GE Nuclear Energy

MFN No. 103-93
Docket No. STN 52-004

Subject: **NRC Request for Additional Information (RAIs) on the Simplified Boiling Water Reactor (SBWR) Design**

Enclosure: RAI Responses

Figure 4.6-2 Fine Motion Control Rod Drive Unit (Cutaway)

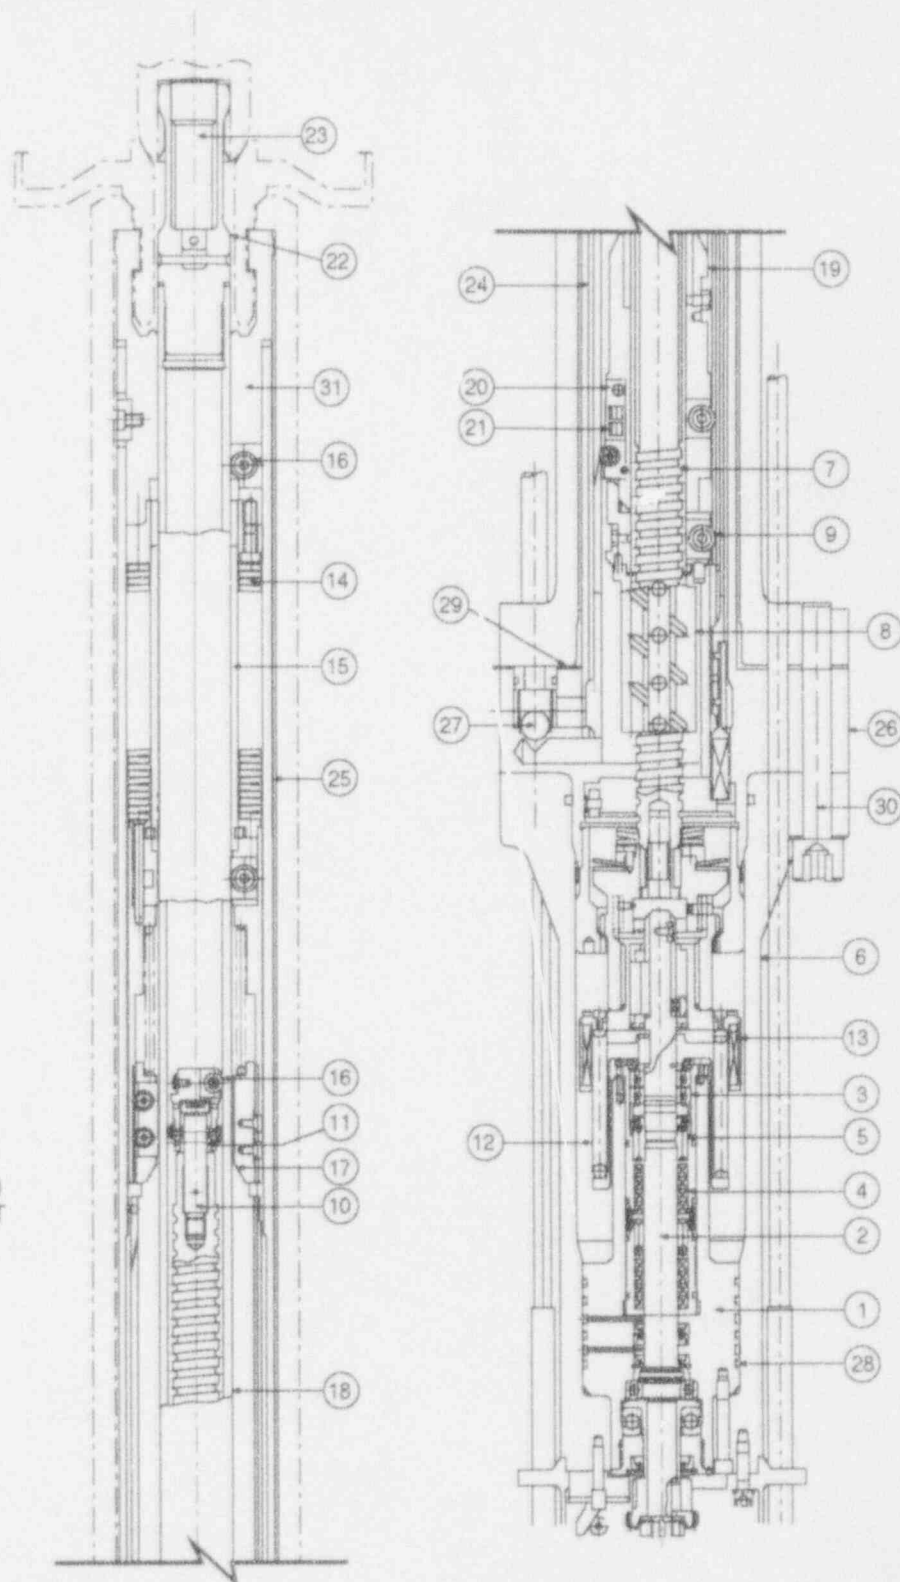
The use of cobalt should be avoided except in cases where no other alternative exist. The applicant should provide justification that no other alternatives exist for the SBWR control rod drive (CRD) system. In addition, Figures 4.6-1 and 4.6-2 of the SSAR should be revised to show the individual assemblies described in Paragraph 4.5.1.1 of the SSAR.

Figure 4.6-2 of the SSAR will be revised to show the individual assemblies described in paragraph 4.5.1.1. of the SSAR. Figure 4.6-1 is a schematic diagram of the drive and will not be changed.

Figure 17.3-1 Design Evaluation for SSCs

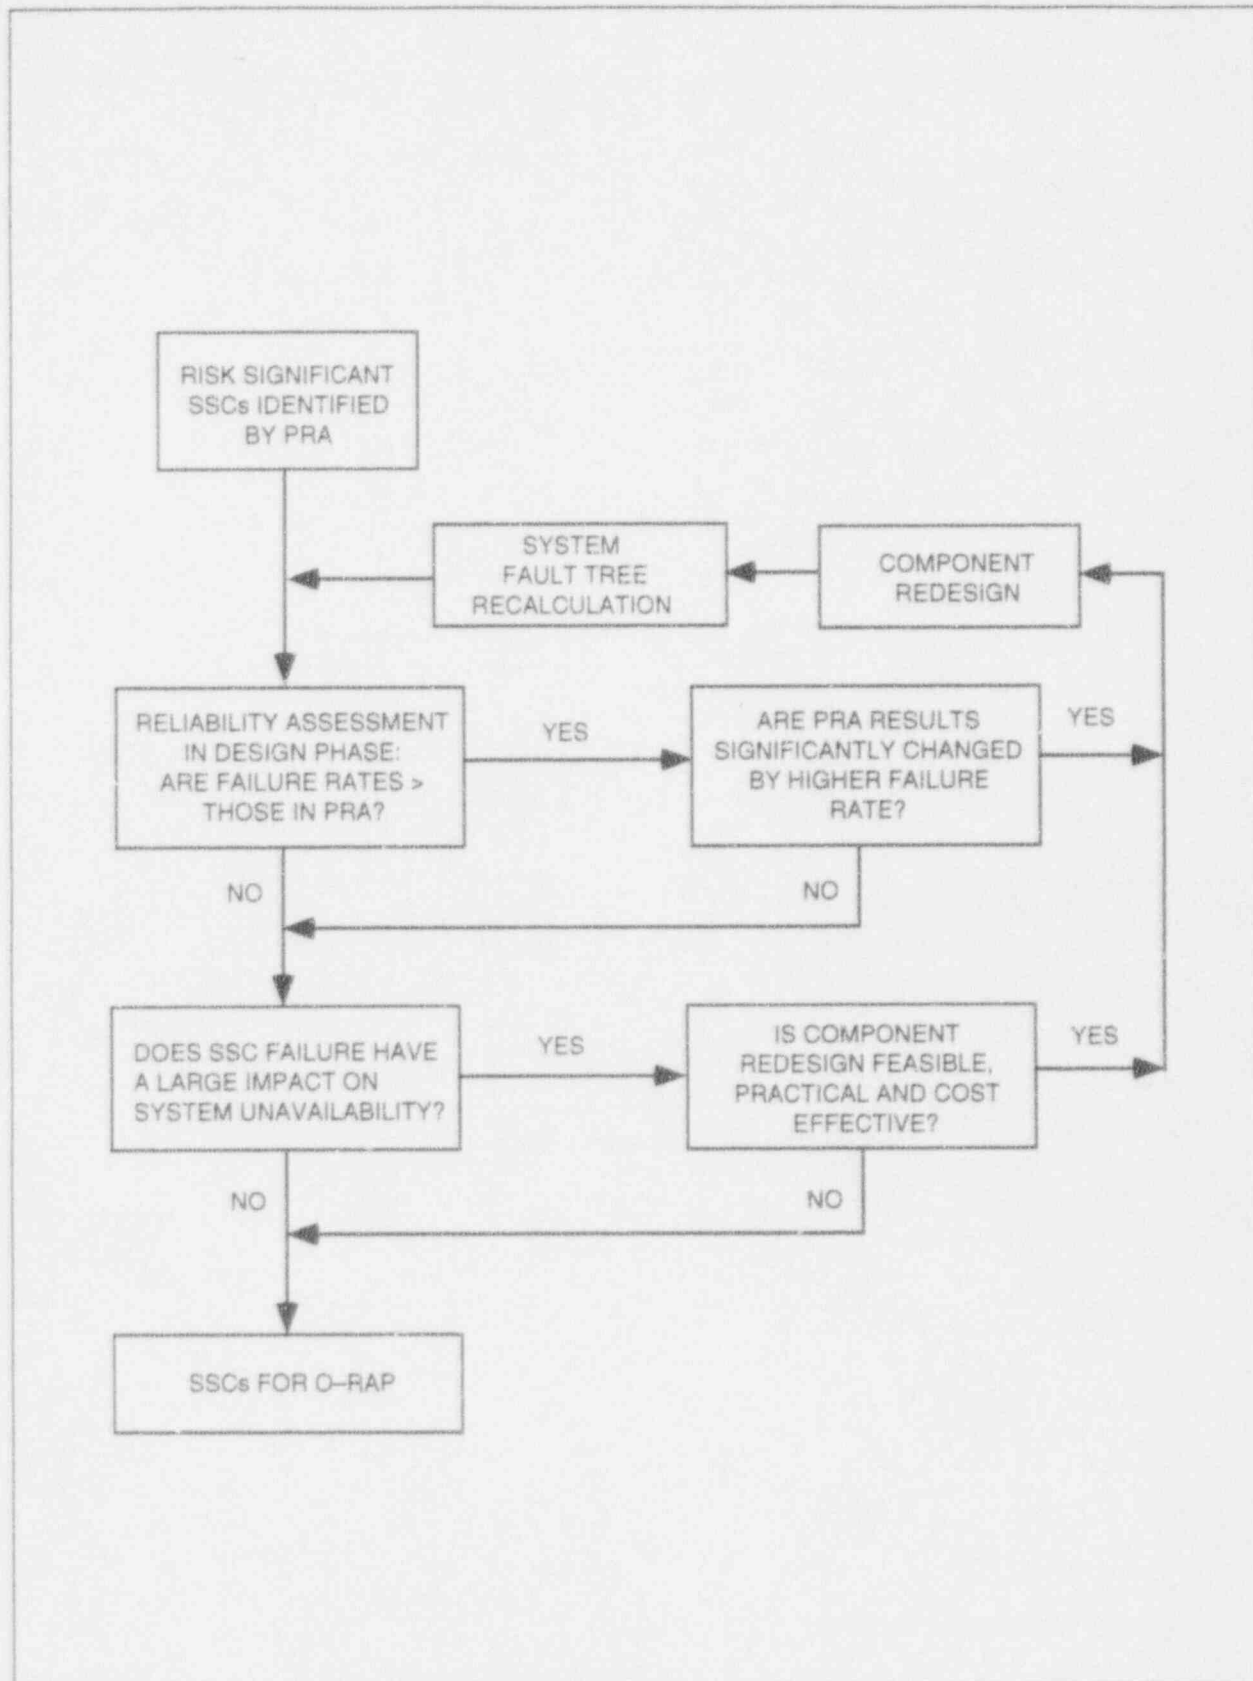
SSAR Section 17.3.11.5 refers to components in Table 17.3-2 as having high importance and uses that result to show how Figure 17.3-2 does not provide a relative measures of the components contribution to core damage frequency. As stated above, Table 17.3-1 also lacks such a measure. GE should provide some relative risk importance measure in these tables so that the system design response argument can be more easily followed.

The ~~three~~ two types of ICS risk-significant components identified in Table 17.3-2 as having high importance in the ICS fault tree are now considered for redesign or for O-RAP activities. The flow chart of ~~Figure 17.3-2~~ Figure 17.3-1 guides the designer.
